**SOAH DOCKET NO. 473-17-1641.WS
PUC DOCKET NO. 46256**

**APPLICATION OF LIBERTY
UTILITIES (WOODMARK SEWER)
CORP., LIBERTY UTILITIES (TALL
TIMBERS SEWER) CORP., LIBERTY
UTILITIES (SUB) CORP. TO CHANGE
RATES FOR SEWER SERVICES IN
SMITH COUNTY, TEXAS**

**LIBERTY UTILITIES' SUPPLEMENTAL RESPONSE TO CITY OF TYLER'S
TENTH REQUEST FOR INFORMATION**

Woodmark Lift Station and Force Main

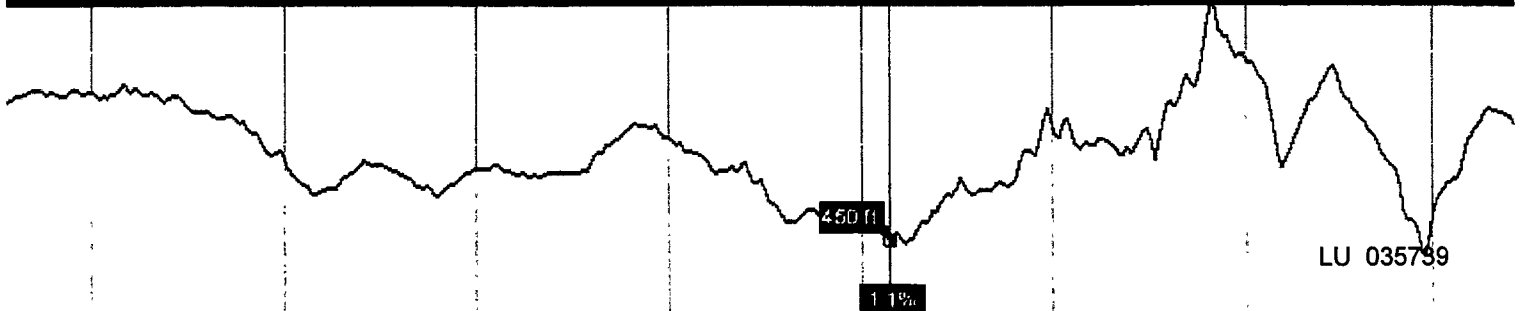
TYLER 10-35 Referencing the rebuttal testimony of Matthew Garlick, Page 5, Lines 22-24, please provide the basis and supporting documentation behind the \$3.2 million figure cited by Mr. Garlick. Please itemize this cost between ?redundancy requirements, design, cost of easements, and other similar factors?.

RESPONSE: Please see attached document not including redundancy line and equipment.
